Subject: REVISION: N222379030-01 – Emission Recall  
Incorrect Catalytic Converter  
Revised Service Procedure

Models: 2022 Chevrolet Equinox  
2022 GMC Terrain

## N222379030 Incorrect Catalytic Converter

**Revision:** 01

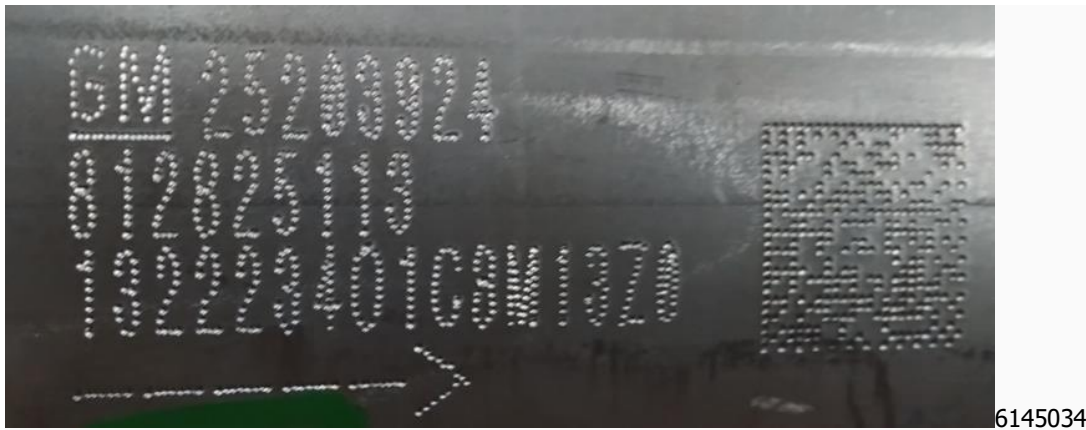
**Note:** The arrow printed below the text will be facing down in the vehicle. Picture has been rotated 90 degrees for clarity.

3. Locate the dot printed part information on the catalytic converter. It is on the side of the converter facing the driver's side of the vehicle, slightly towards the rear.

4. Determine if the part number (top row) ends in 3459 (bad part) or 3924 (good part).
  - If the part number ends in 3459, OR if the number is illegible, replace the Catalytic Converter. Refer to *Warm Up Three-Way Catalytic Converter Replacement* in SI.

- If the part number ends in 3924, no further action is required.
5. Close the hood.
6. CALIFORNIA, COLORADO, CONNECTICUT, DELAWARE, MAINE, MARYLAND, MASSACHUSETTS, NEW JERSEY, NEW YORK, OREGON, RHODE ISLAND, VERMONT, WASHINGTON VEHICLES ONLY: Install a Recall Identification Label upon recall completion. See General Motors Service Policies and Procedures Manual, Recall Identification Label, for details.
